### HISTORIC DISTRICT COMMISSION

Regular meeting

6:30 p.m. September 3, 2025

- A. Certificate of Appropriateness Application: **311 W. Orange St.** - New construction house (PIN 9864883297)

DATE OF SURVEY: 10/27/2025  
SCALE: 1" = 20'  
DRAWN BY: OL  
CHECKED BY: ANC  
PROJECT: 311 W ORANGE  
SHEET: 1/1

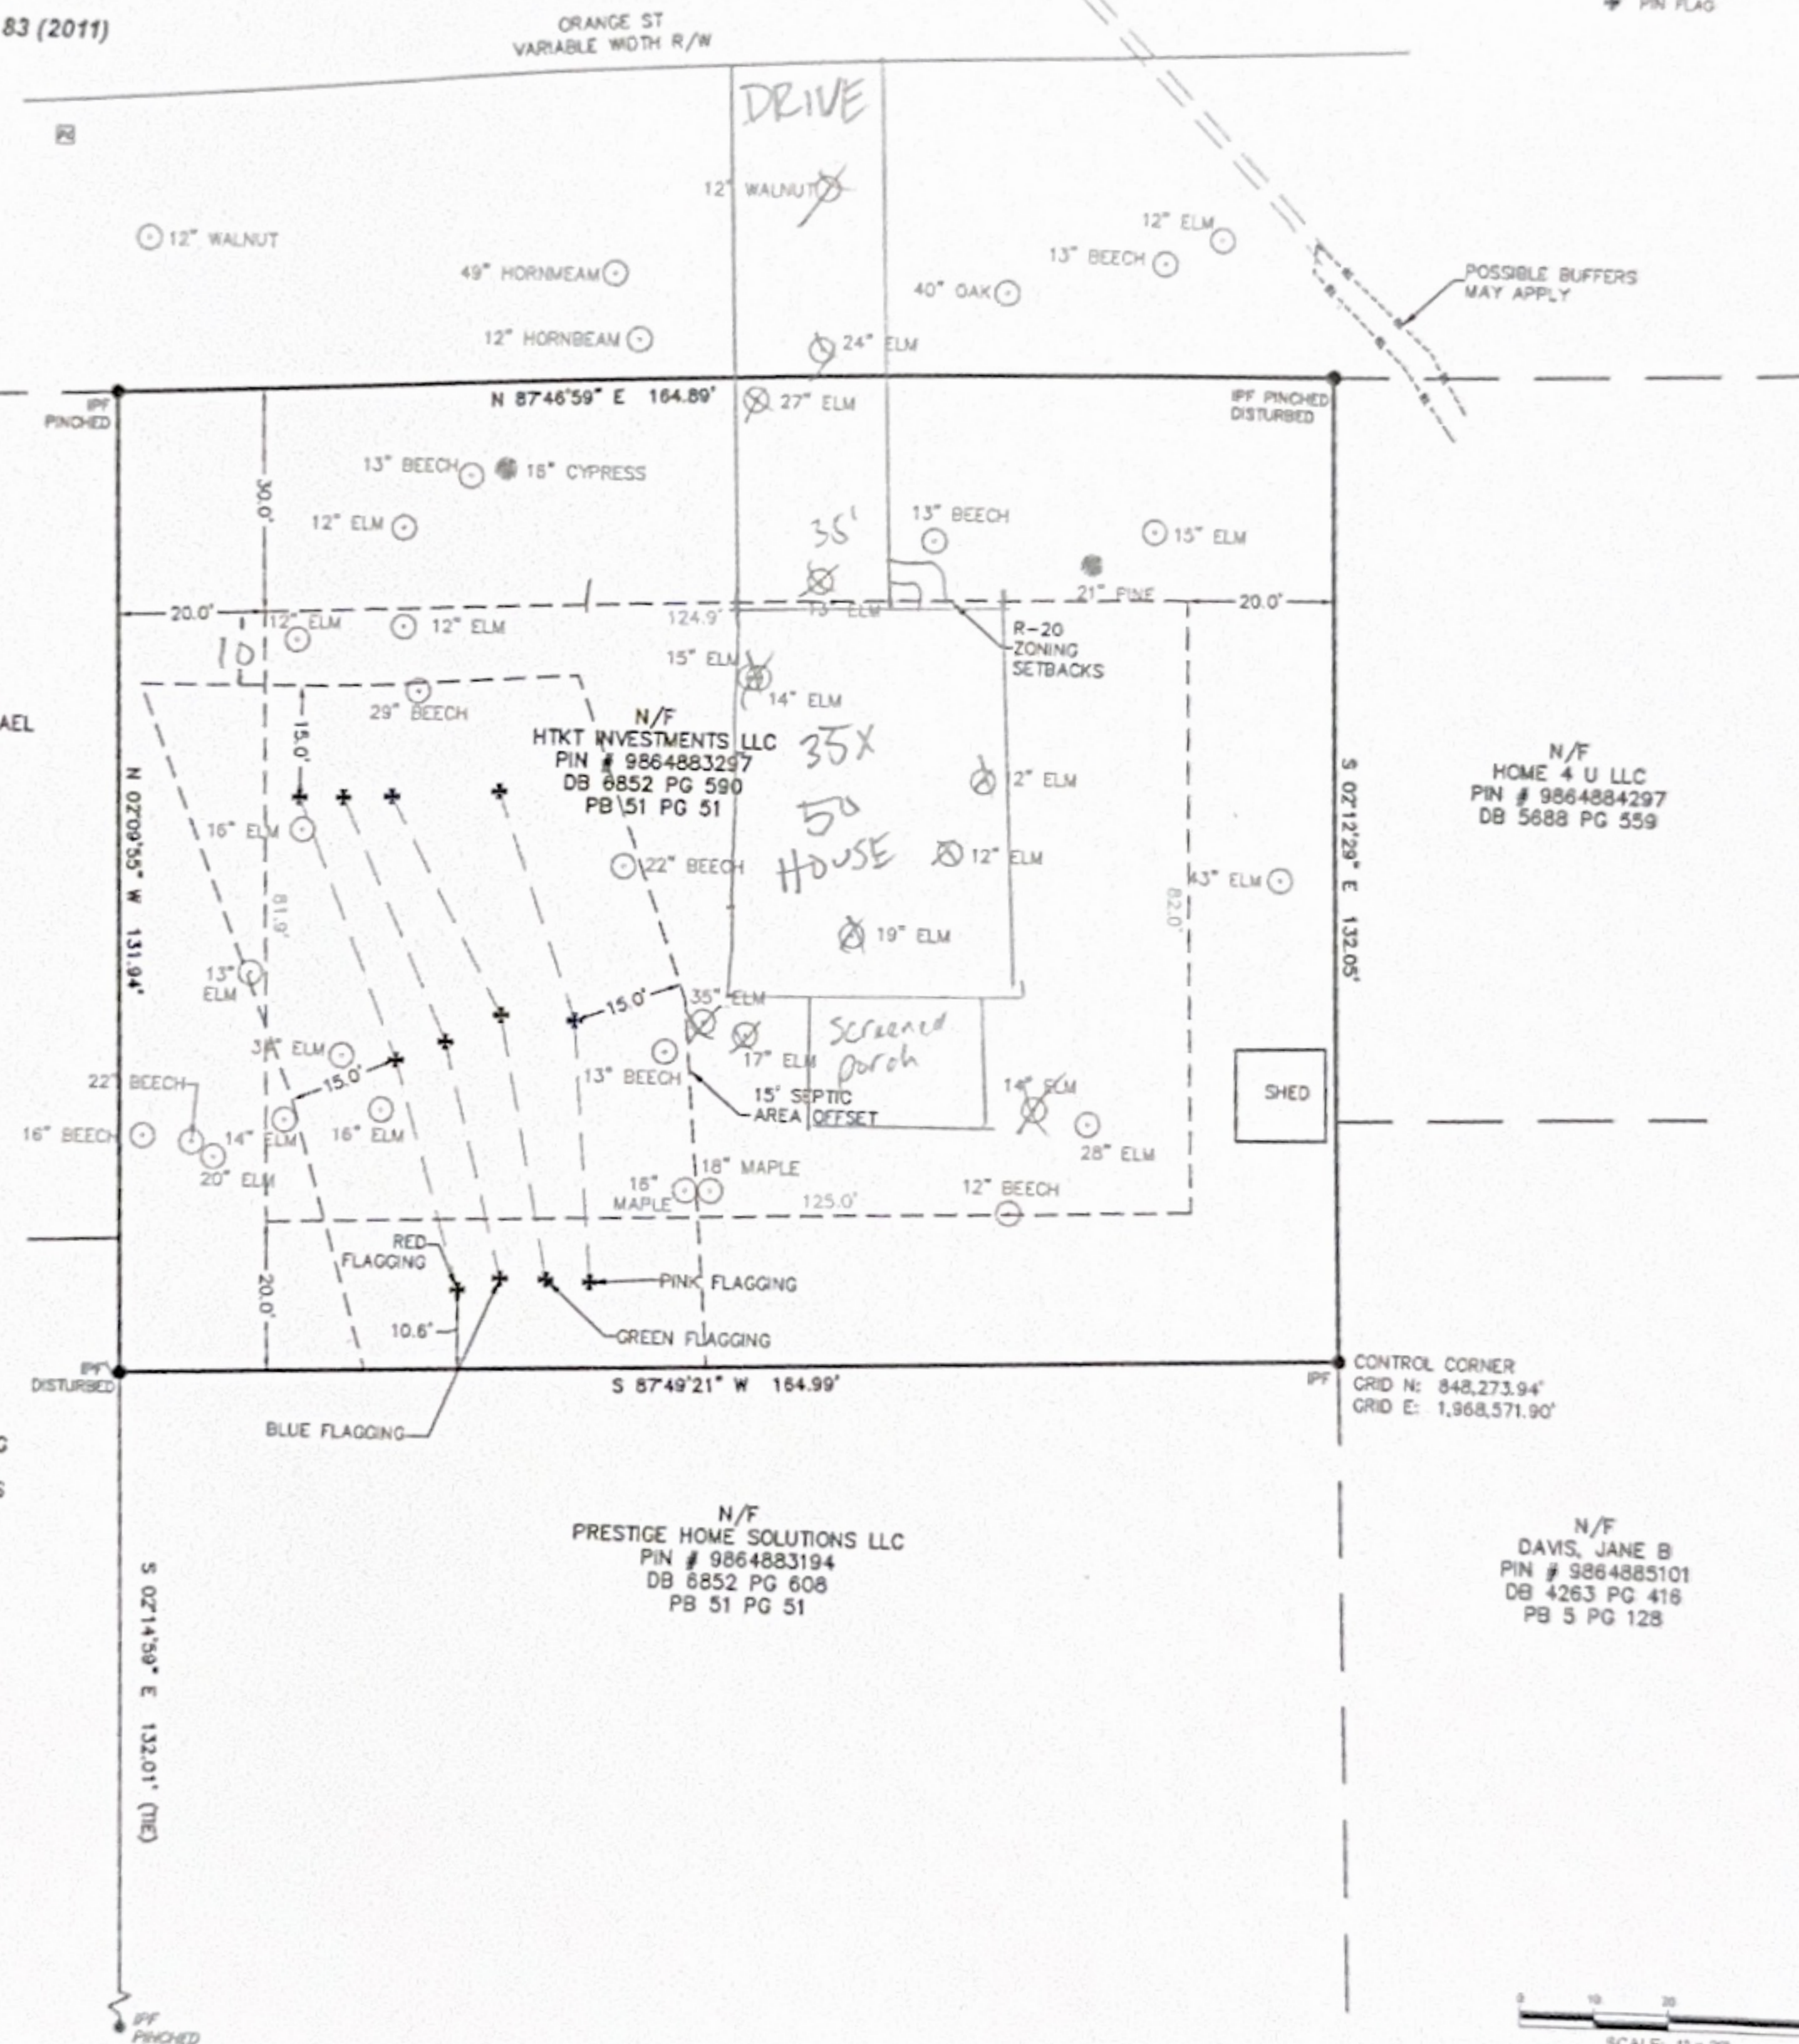
- The site plan appears to indicate that four trees with diameters over 24 inches will be removed for construction of the house, and one will be removed for the septic drain field. Some of those trees are in the public right-of-way but were indicated on the site plan. The applicant can propose to remove those for this review, and after that they would go to the Public Space and Sustainability Division, who would approve the removal if the proposed removal had received a Certificate of Appropriateness from the Historic District Commission. Staff are not aware of any recent new construction for which that many trees of that size were removed.

The commissioners reviewed the site plan. The commissioners noted the absence of materials listed for the new walk from the drive to the house. Hoffheimer confirmed that the shed on the site plan is existing. The commissioners observed that the drive may fit between the 24-inch elm and 40-inch oak without removing either one and wondered why the applicant did not take that approach.

The commissioners discussed the potential need for grading the site to build the house on a flat foundation as rendered. They requested that a grading plan be submitted and the elevations be drawn as accurately as possible with regard to the slope of the site.

There was discussion of the septic drain field. Hoffheimer said that the applicant is building a septic system because the site is over 100 feet away from a sewer line. It was noted that the trees within the septic field are not indicated for removal on the site plan, but the commissioners speculated that they would have to be removed for that purpose. Town attorney Bob Hornik clarified that because the site is over a certain distance from the sewer line, connection to the town's sewer system is not required for this site, though it is possible. He added that if the site were to connect to the town sewer, a pump would be required. Hoffheimer noted that many of these changes could fall under New Construction of Primary Residential Buildings Standards 2-5.
